DESIGN	RF	DART AEROSPACE LTD	
DRAWN	RF	HAWKESBURY, ONTARIO, CANADA	
CHECKED	140	DRAWING NO.	REV. E
MFG. APPR.	140	D2580	SHEET 3 OF 8
APPROVED	140	TITLE	SCALE
DE APPR.	140	205 SKIDTUBE ASSEMBLY	NTS
DATE	11.06.21	COPYRIGHT © 1996 BY DART AEROSPACE LTD THIS DOCUMENT IS PRIVATE AND CONFIDENTIAL AND IS SUPPLIED ON THE EXPRESS CONDITION THAT IT IS NOT TO BE USED FOR ANY PURPOSE OR COPIED OR COMMUNICATED TO ANY OTHER PERSON WITHOUT WRITTEN PERMISSION FROM DART AEROSPACE LTD.

DRAWING NO. D2580	TITLE 205 SKIDTUBE ASSEMBLY	REV. E	DART AEROSPACE LTD ENGINEERING ORDER		D.E.O. NO. D2580-E-1	SHEET NO. SHEET 1 OF 1	SCALE NTS
DRAWN <i>UP</i>	CHECKED <i>ASS</i>	MFG. APPR. <i>EC</i>	APPROVED <i>[Signature]</i>		DE APPR. <i>[Signature]</i>		
DATE 11.12.13	DATE 11.12.13	DATE 11.12.13	DATE 11.12.13		DATE 11.12.13

CHANGE ALL C'BORED WELDED CROSSBOLT SPACERS TO SWAGED SPACERS

D2580-045 ASSEMBLY DETAIL

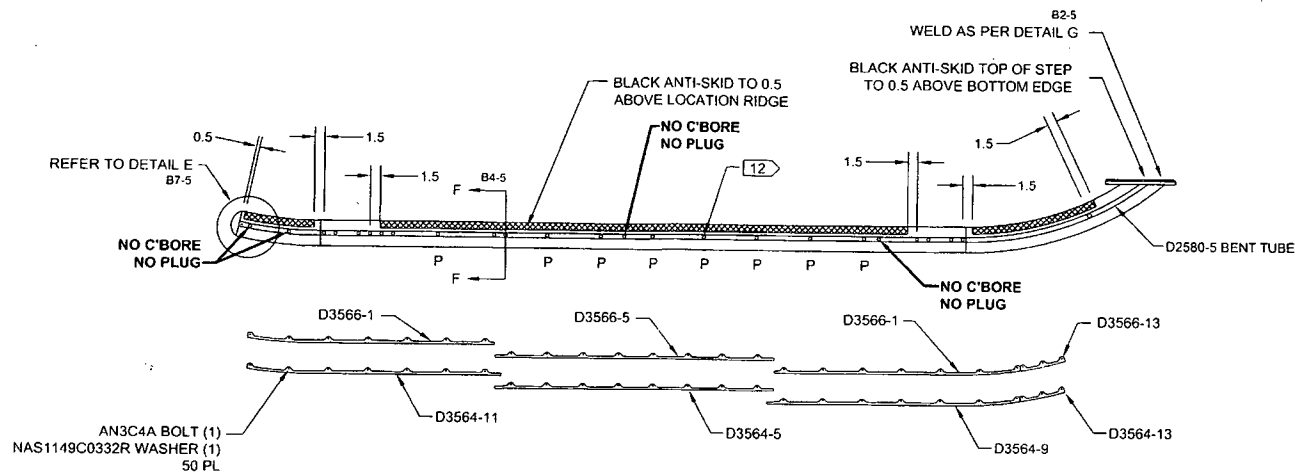
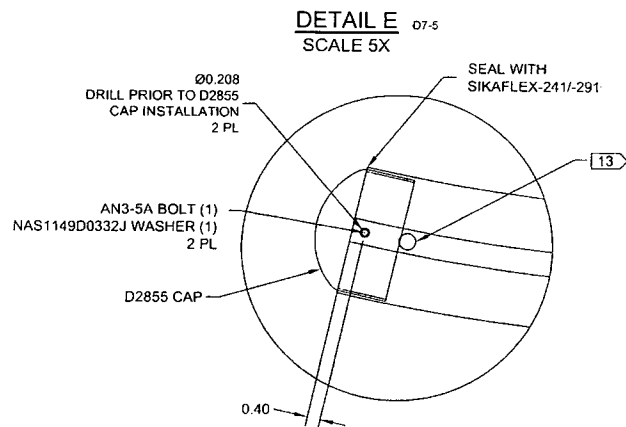
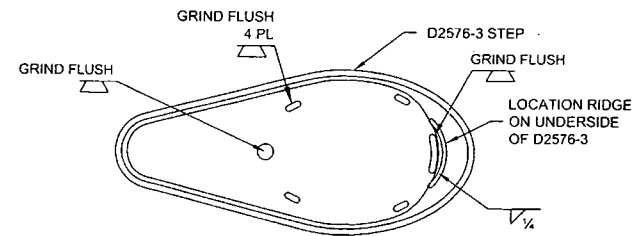
*** FOR -045 SKIDTUBE ONLY:**
WELD 4X D2579 SPACERS PER DWG
IN LOCATIONS MARKED "NO C'BORE".
REF SHEET 4 OF DWG.

SECTION F-F
D5-5
SCALE 5X

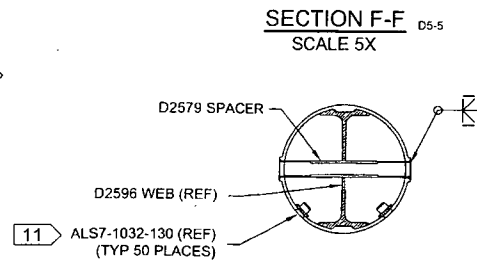
SECTION B-B, SECTION F-F, & SECTION I-I ARE AMENDED AS FOLLOWS
FOR ALL HOLES THAT WERE ORIGINALLY C'BORED:

1. INSERT D4202-1 SPACER, 20 PL (-041) OR 20 PL (-045) OR 25 PL (-047)
2. SWAGE TO Ø0.437 X 1.00 DEEP PER QSI 002
3. TRIM / GRIND FLUSH PER QSI 002
